Public Input No. 2423-NFPA 70-2023 [Global Input]

Public Input No. 3086-NFPA 70-2023 [Global Input]

Figure 1

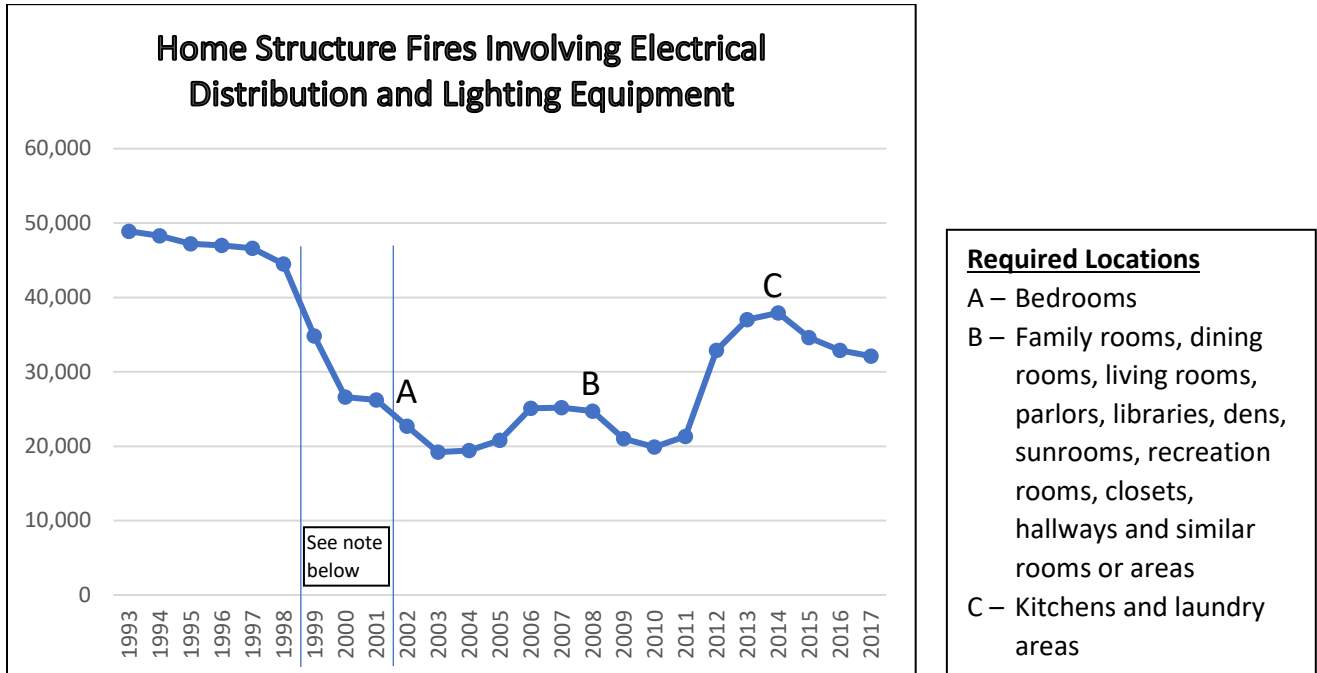
The current fire data coming from NFPA should give us pause. There is no empirical, real-world data we can point to supporting the expansion of AFCI requirements. Quite the opposite—we now see that the installation of tens of millions of AFCI devices has not had a noticeable effect on fire data. As millions of AFCI devices were being installed, home fires involving electrical distribution and lighting equipment experienced a dramatic increase between 2010 and 2014 (see Figure 1)—the numbers of fires jumped from 19,900 to 37,900 in that period.

Figure 2: GFCI Protection in Homes Versus Electrocutions 1975 to 2018 (Source: A NEMA Ground Fault Personnel Protection Section Article entitled “GFCI Receptacles: Consumer Protection Personified” June 2020, Revision 2).

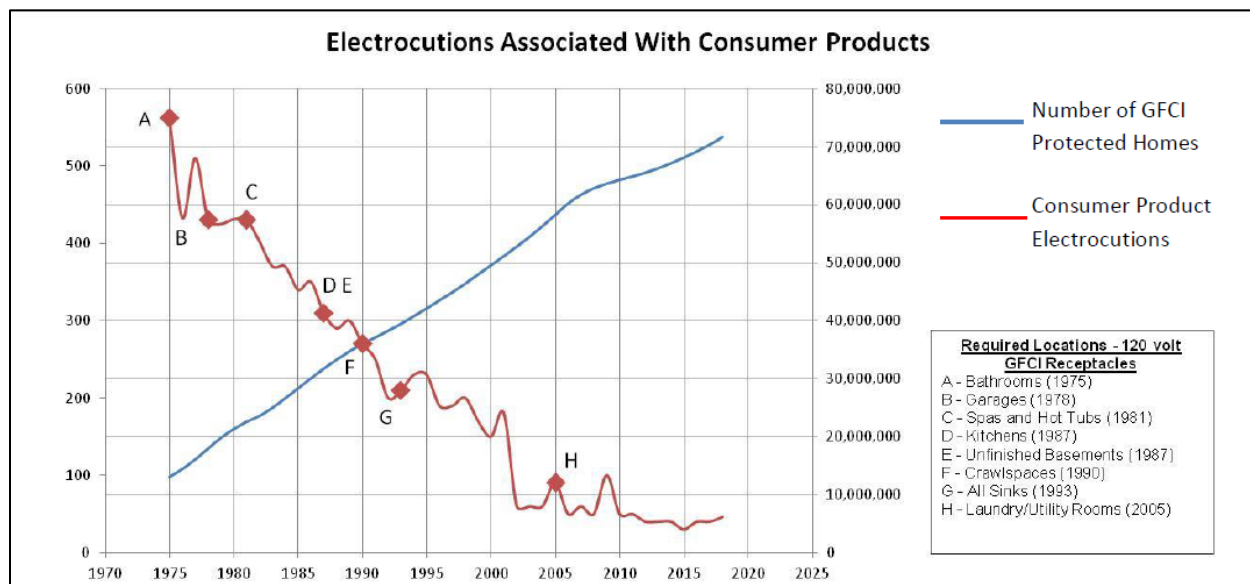
In contrast to the data surrounding AFCIs, there is a clear relationship between the early adoption of GFCIs and the reduction in electrocutions (see Figure 2). This is the effect we should be expecting from AFCIs as well, but we are not seeing anything similar to the benefit GFCIs have provided.

Figure 3

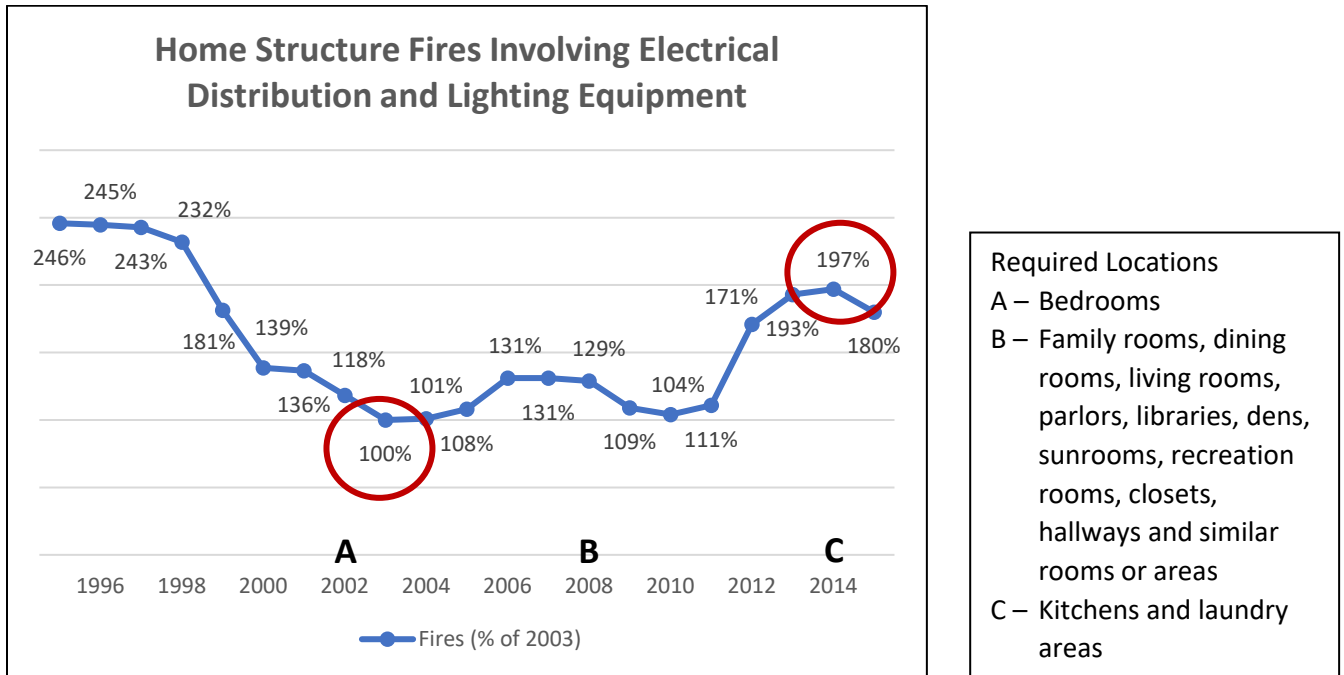
Another way to look at the AFCI data is to show the increase in fires as a percent of the low water mark of 2003. After 2008, when the bulk of circuits in a home were required to be covered by an AFCI device, fires incidents reached their highest number since 1998—a nearly 100% increase over 2003.

Figure 1

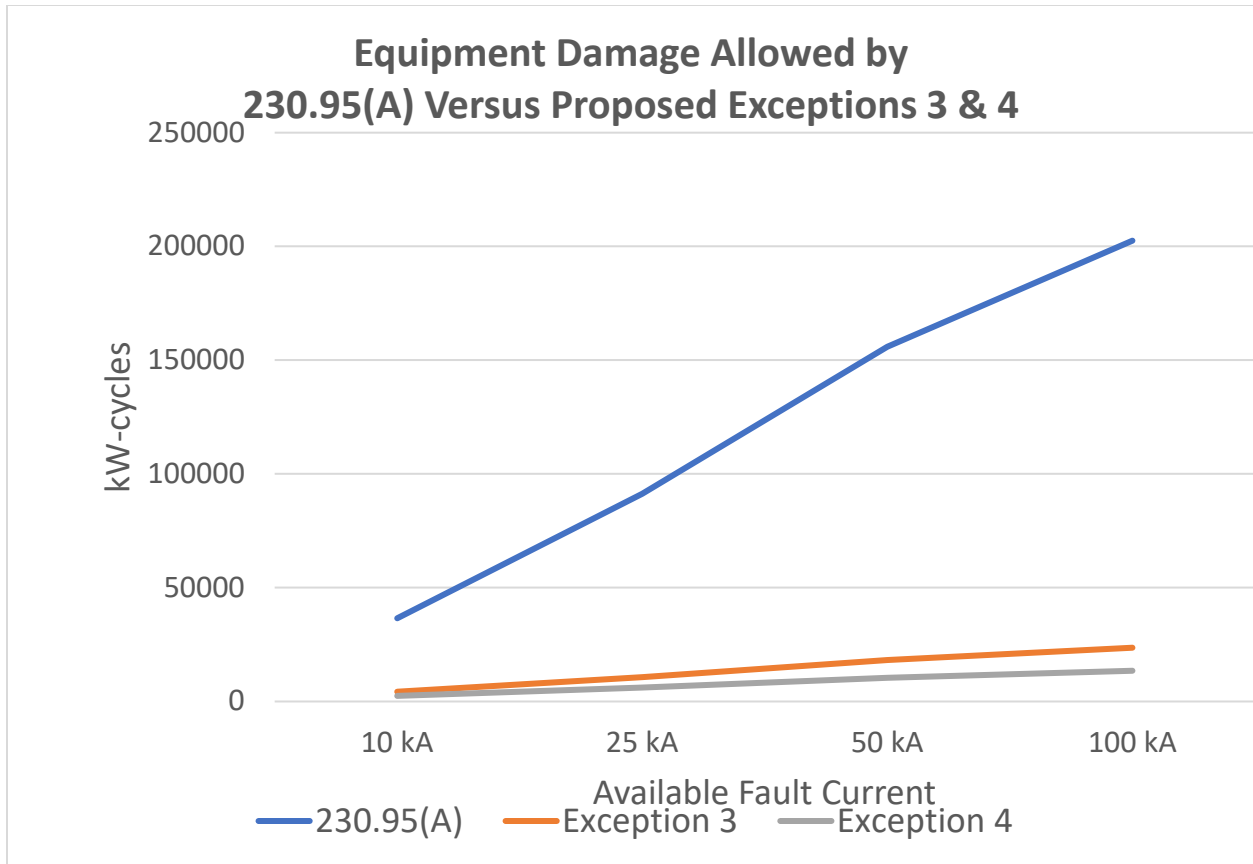
As allowed by 230.95(A). The IEEE 1584-2018 minimum arcing current is 6.09kA. Using the maximum 230.95(A) opening time of 60 cycles, the equipment damage is (6.09 kA X 60 cycles X 100 arcing volts) = 36,540 kW-cycles. See Figure 1.

As allowed by 230.95(A). The IEEE 1584-2018 minimum arcing current is 15.21kA. Using the maximum 230.95(A) opening time of 60 cycles, the equipment damage is (15.21 kA X 60 cycles X 100 arcing volts) = 91,260 kW-cycles. See Figure 1.

breakers (6,084 kW-Cycles) is less than 7% of the worst-case damage allowed by 230.95(A) (91,260 kW-cycles). See Figure 1.

As allowed by 230.95(A). The IEEE 1584-2018 minimum arcing current is 25.98kA. Using the maximum 230.95(A) opening time of 60 cycles, the equipment damage is (25.98 kA X 60 cycles X 100 arcing volts) = 155,880 kW- cycles. See Figure 1.

As allowed by 230.95(A). For an available fault current of 100kA, the IEEE 1584-2018 three phase minimum arcing current is 33.75 kA. Using the maximum 230.95(A) opening time of 60 cycles, the equipment damage is (33.75 kA X 60 cycles X 100 arcing volts) = 202,500 kW-cycles. See Figure 1.

As allowed by Proposed Exception No. 4. For an available fault current of 100kA, the IEEE 1584-2018 minimum arcing current is 33.75 kA. Assuming an opening time of 4 cycles for 240.87(B)(1), (B)(2), or (B)(4), the equipment damage is (33.75 kA X 4.0 cycles X 100 arcing volts) = 13,500 kW-cycles. Assuming an opening time of 3 cycles for 240.87(B)(5) or (B)(6), the equipment damage is (33.75 kA X 3 cycles X 100 arcing volts) = 10,125 kW-cycles. Worst-case damage for the minimum arcing current with this proposed exception for circuit breakers (13,500 KW-Cycles) is less than 7% of the worst-case damage allowed by 230.95(A) (202,500 kW-cycles). See Figure 1.

Figure 1 shows that equipment damage allowed by this Public Input is always, from 10,000 amperes available through 100,000 amperes available, just a small fraction of the equipment damage allowed by 230.95(A).

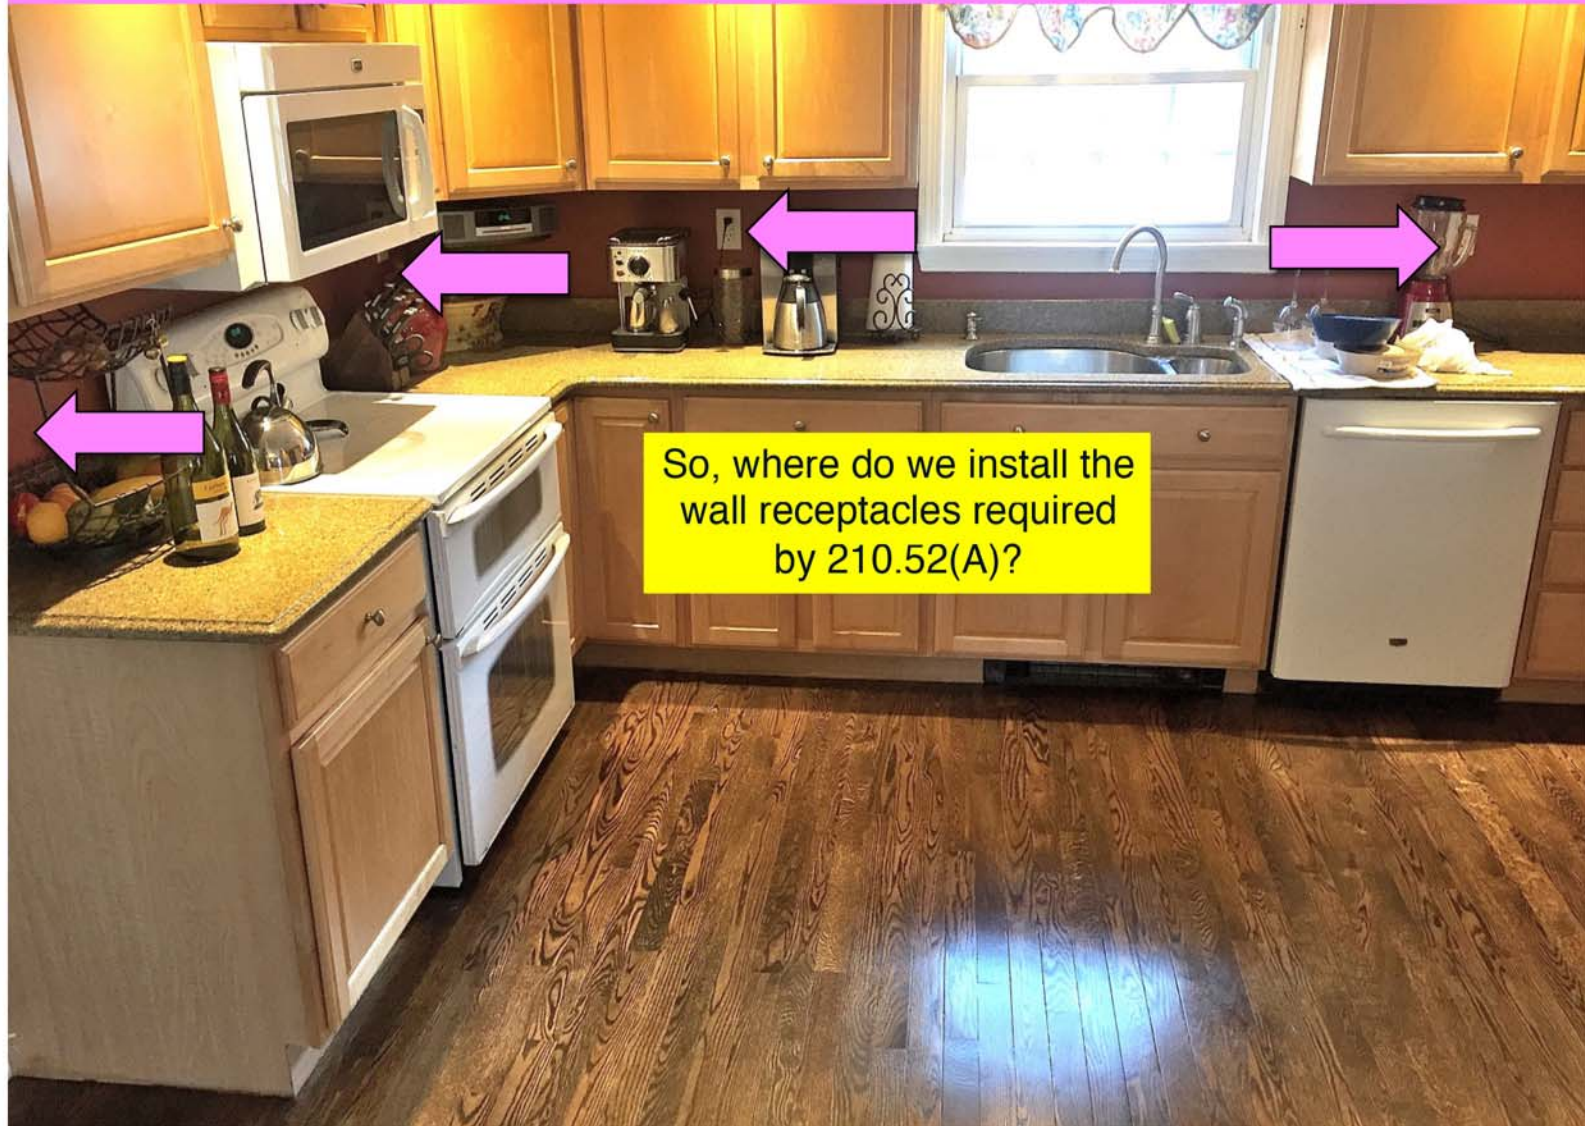
This means the wall spaces at kitchen cabinets having countertops are included in this requirement!

These receptacles cannot be used to satisfy 210.52(A) requirements!

But, according to 210.52(A)(4) and 210.52(C), Receptacles installed for countertop and similar work surfaces SHALL NOT be considered as the wall space receptacle outlets required by 210.52(A)

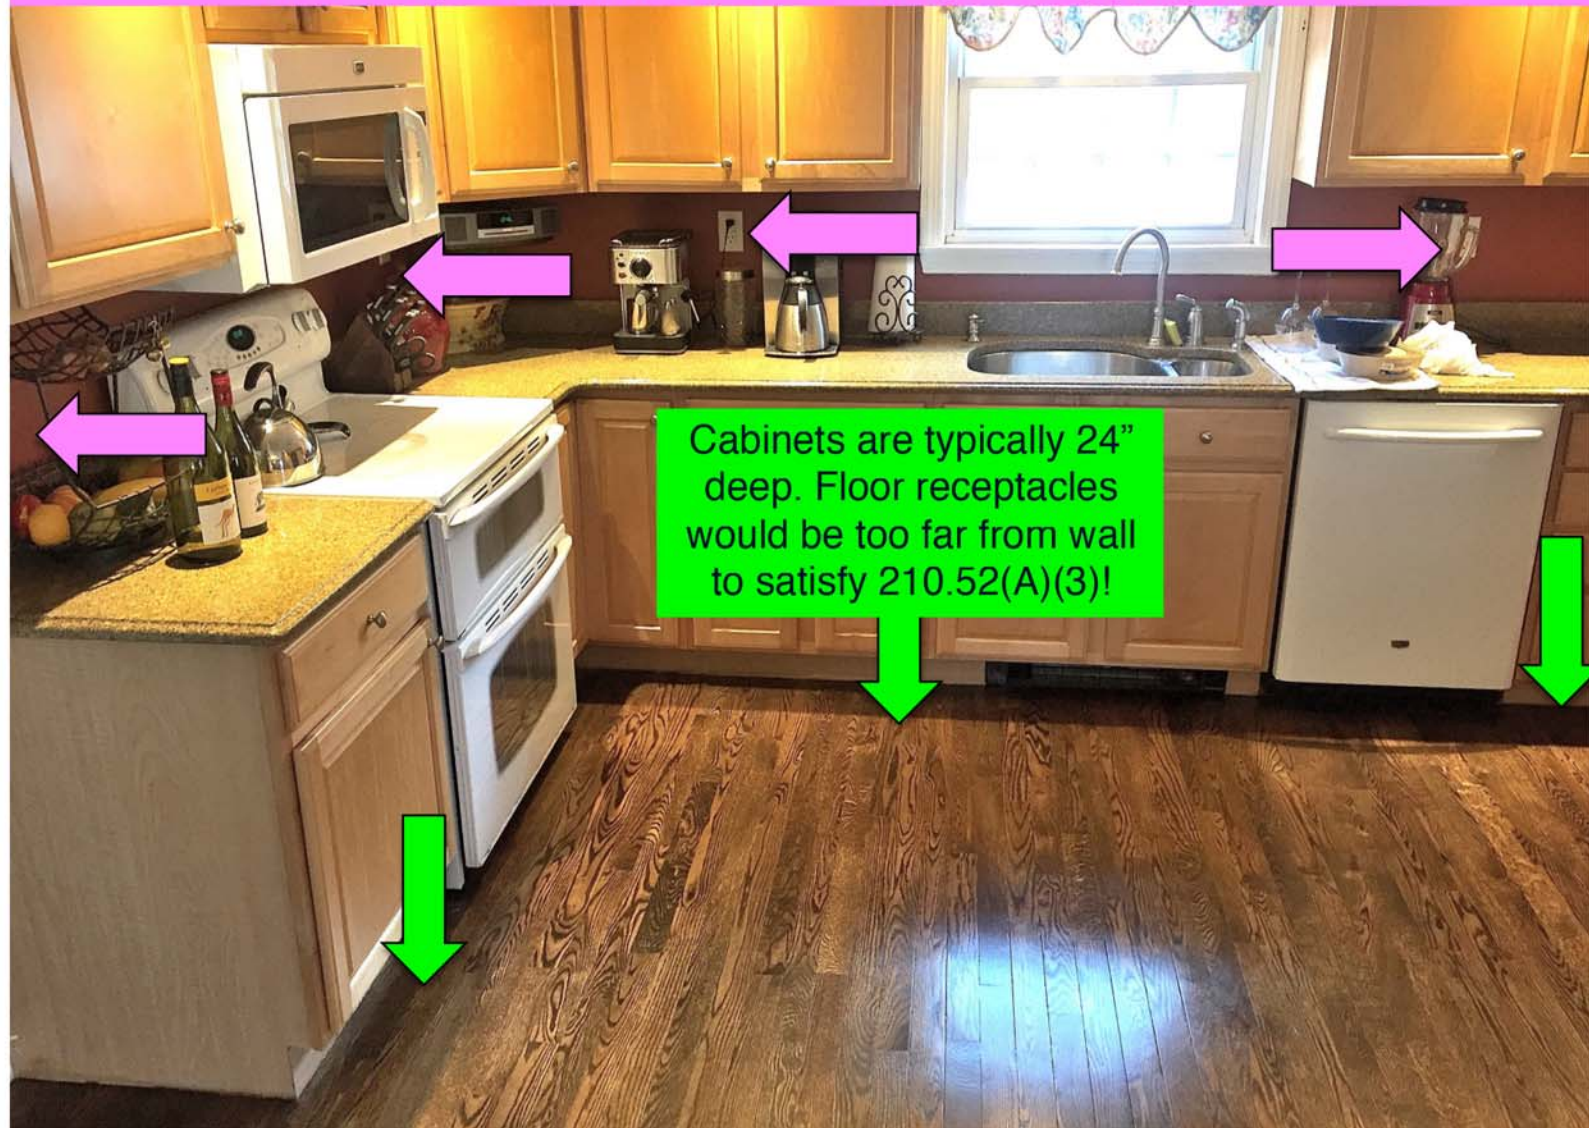
So, where do we install the wall receptacles required by 210.52(A)?

These receptacles cannot be used to satisfy 210.52(A) requirements!

Cord pendants per 210.50(A) would be impractical since they would interfere with opening the upper cabinet doors!

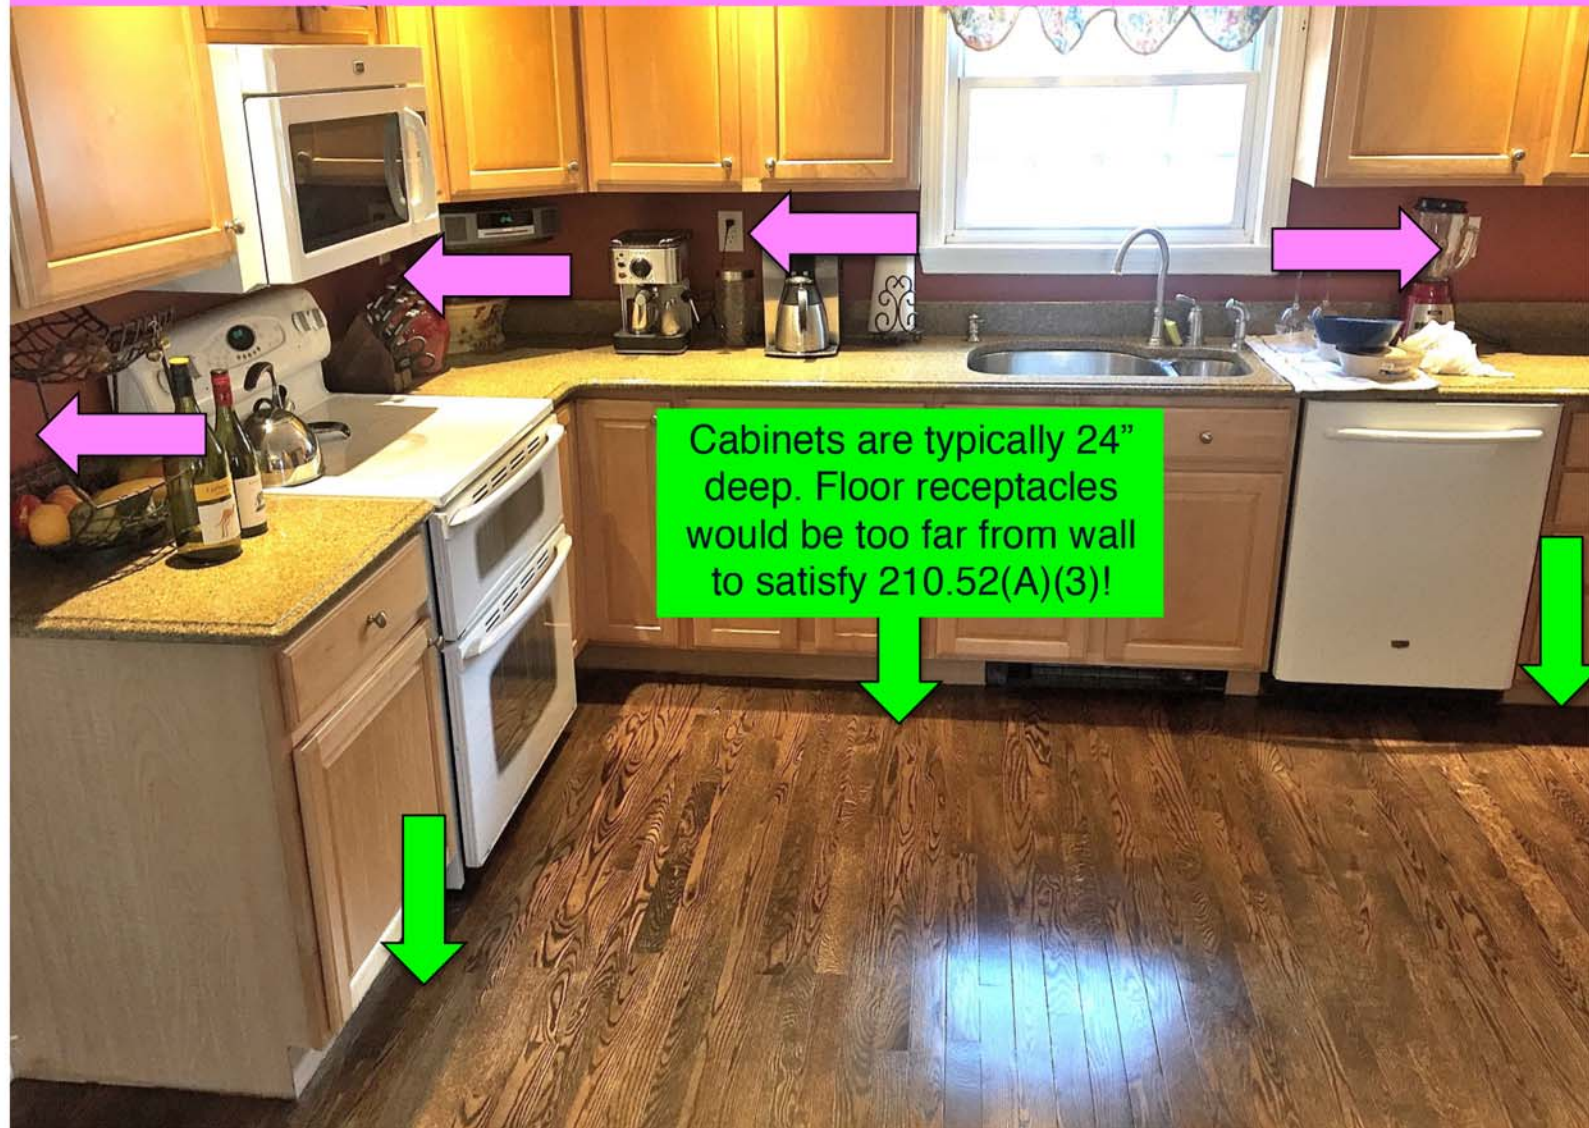
These receptacles cannot be used to satisfy 210.52(A) requirements!

But, according to 210.52(A)(4) and 210.52(C), Receptacles installed for countertop and similar work surfaces SHALL NOT be considered as the wall space receptacle outlets required by 210.52(A)

These receptacles cannot be used to satisfy 210.52(A) requirements!
